GEORGE M.
JANES &
ASSOCIATES

RE: Comments related to Silo Ridge's
August 21, 2014 submission

Figure 13: Detail from SL1.06 showing up-lit spotlights

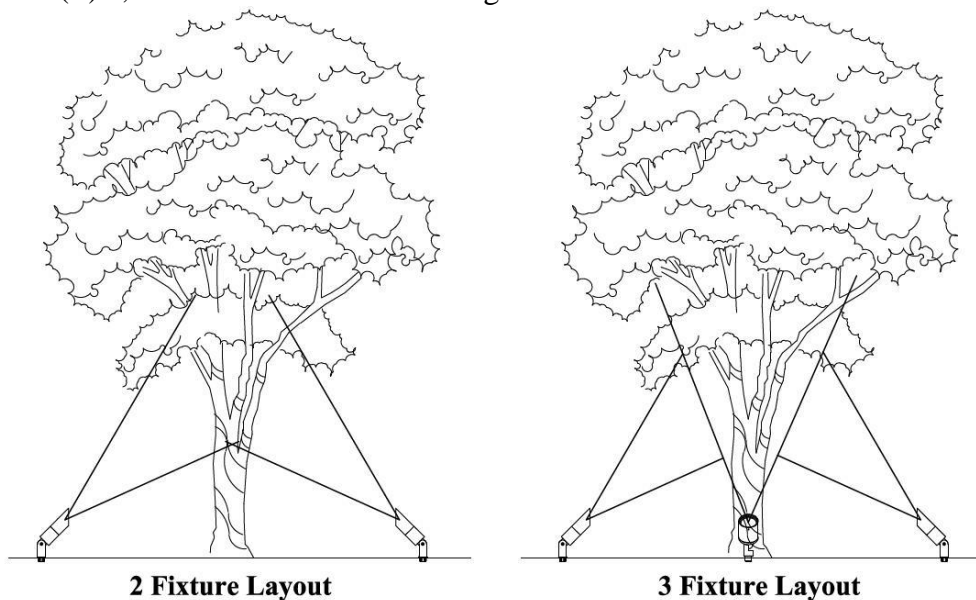
In addition to the Square Gold Start LED mentioned above, the project calls for over 100 MR11 Halogen spotlights to up-light trees. The following image shows

how these spotlights are to be used. Both of these lights violate the Town's zoning 121-40(L)¹¹, which states that exterior lights need to be directed downward.

Figure 15: MDP SP4 draped on Google Earth elevation model of the town, to demonstrate the issue with changing elevation in 3D

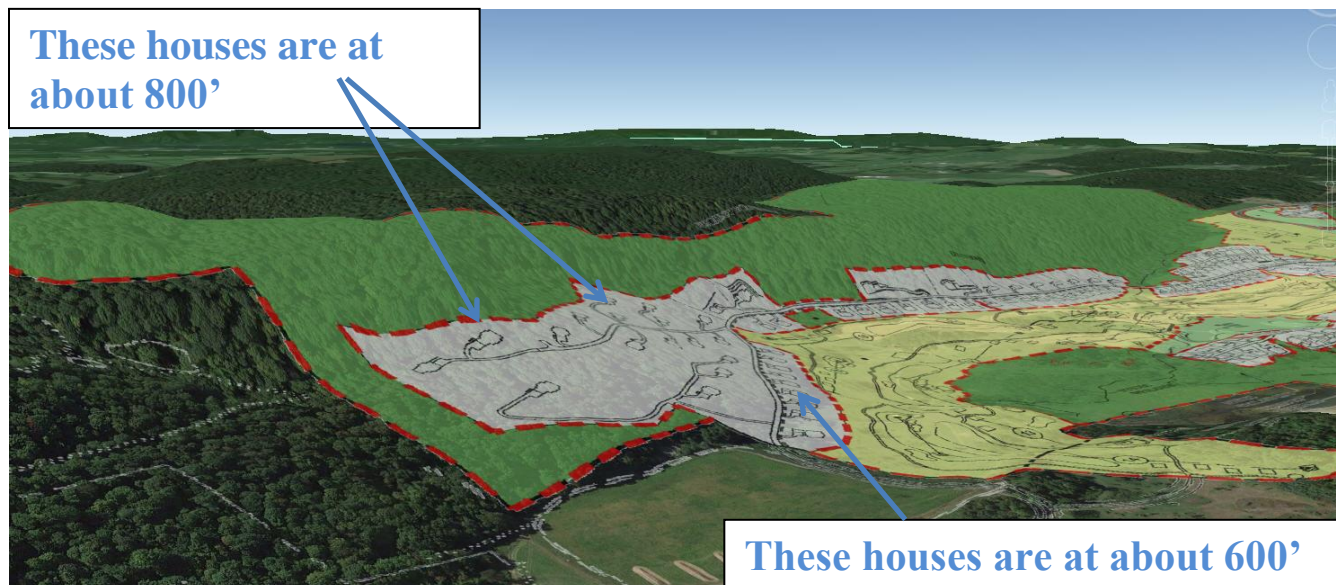
The houses that line the golf course are at about elevation 600 feet. The houses at the highest portion of the development are at about elevation 800 feet. The changing elevation means that houses cannot be used to hide each other and appear to climb up the hillside as seen in photosimulation:

Figure 17: Alternative 1, which keeps the 26 houses in this area, but moves several to the access road for the project, which increases the amount of open space by about 10 acres

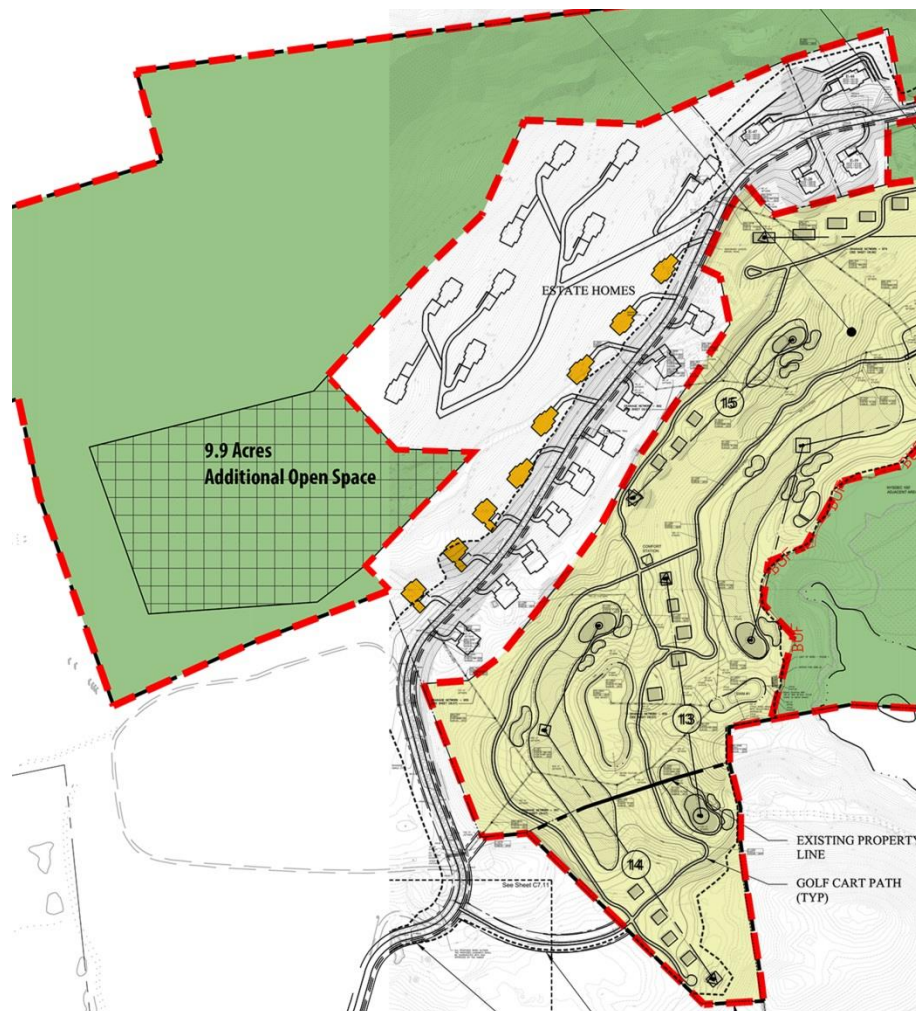
This alternative simply removes the middle road planned for the hillsides, and moves the houses planned there to double-load the southern access road (shown in orange). It also clusters the upland houses in groups of four off of a shared access. This change would add another 10 acres into open space, but would still show houses climbing up the hillside.

Figure 18: Alternative 2: Remove six houses from the higher elevations to the access road to the south. This would require a lot line adjustment and the upgrade of a golf cart path

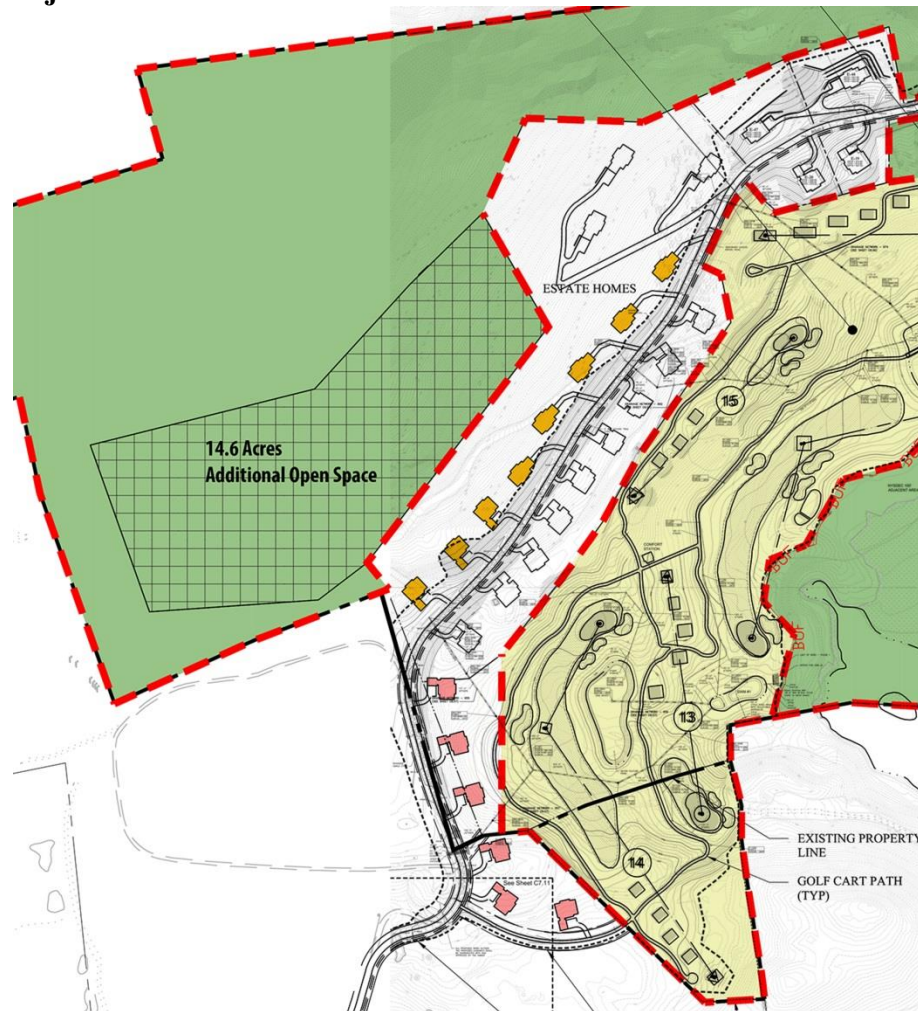
In Alternative 2, in addition to double-loading the access road, six of the houses from the highest area would be moved to lower elevations, five off the access road and a sixth off what is now planned as a golf cart path, which would have to be improved. Alternative 2 adds close to 15 acres to open space and removes the vast majority of houses from the highest elevations. While there would still be a couple of houses stepping up the hillside, a design like this would materially shrink the area that is impacted.

Figure 19: Alternative 3: Double-loads the access road and removes all houses at higher elevation. Reduces the number of houses in this section to the approved MDP

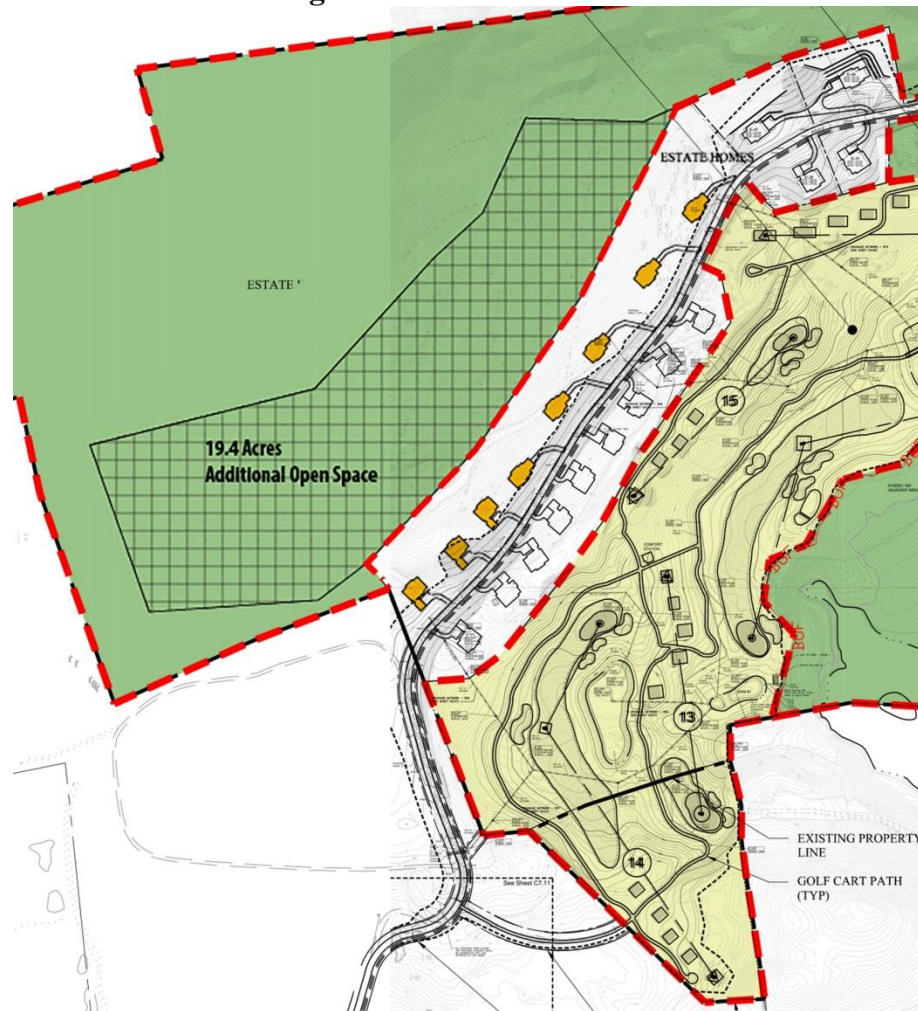
The 2009 MDP for the phase 2 estate homes shows only 17 houses, not the 26 shown in the current MDP. Alternative 3 starts with the 17 houses that were approved in 2009 and removes all the houses from the highest elevations. The fewer number of houses removes the need for Alternative 2's lot line adjustment. Alternative 3 adds over 19 acres to open space and keeps access to all of the estate homes from the main access road. Alternative 3 changes the layout of the 2009 MPD, which while including some houses on the access road, also showed houses further up the hillside. The following shows the 2009 MDP with the Phase 2 area highlighted. Houses outside this highlighted area are in Phase 1:
